NISSAN FRONT OR REAR DRIVE PREMATURE PLANETARY FAILURE

COMPLAINT: Planetary gears failed due to lack of lubrication, while the hydraulic system and friction material does not seem to be damaged.

Figure 2

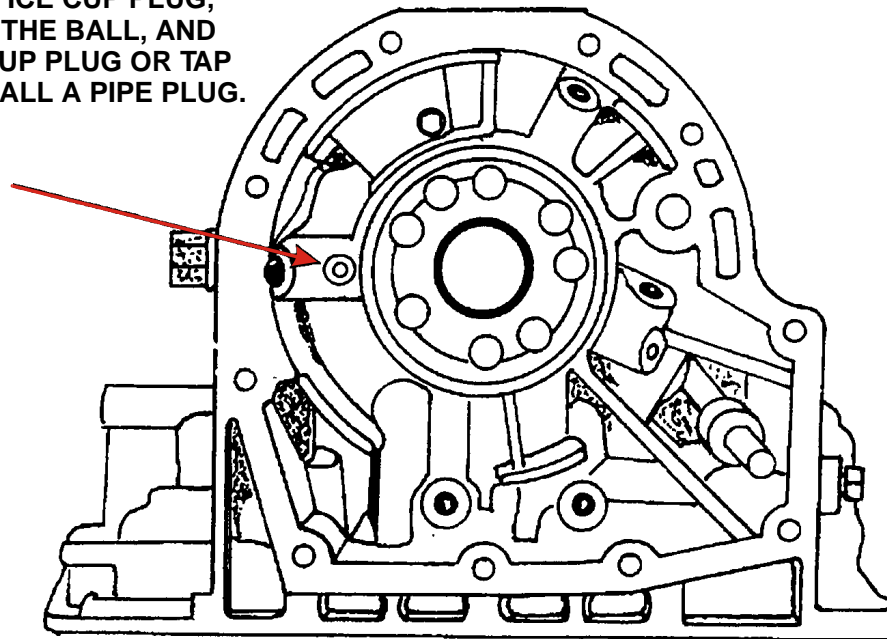
Check the case bushings for wear and replace them if they are worn. Also make sure that the case bushings have not moved so that they block the lubrication feed passage to the output shaft. To assure maximum lube to the output shaft and planets, remove and discard the orificed cup plug, the lube relief ball, and the spring as shown in figure 2 and **INSTALL A SOLID PLUG IN PLACE OF THE ORIFICED CUP PLUG.**

**REMOVE THIS ORIFICE CUP PLUG,
THE SPRING, AND THE BALL, AND
INSTALL A SOLID CUP PLUG OR TAP
THE CASE AND INSTALL A PIPE PLUG.**
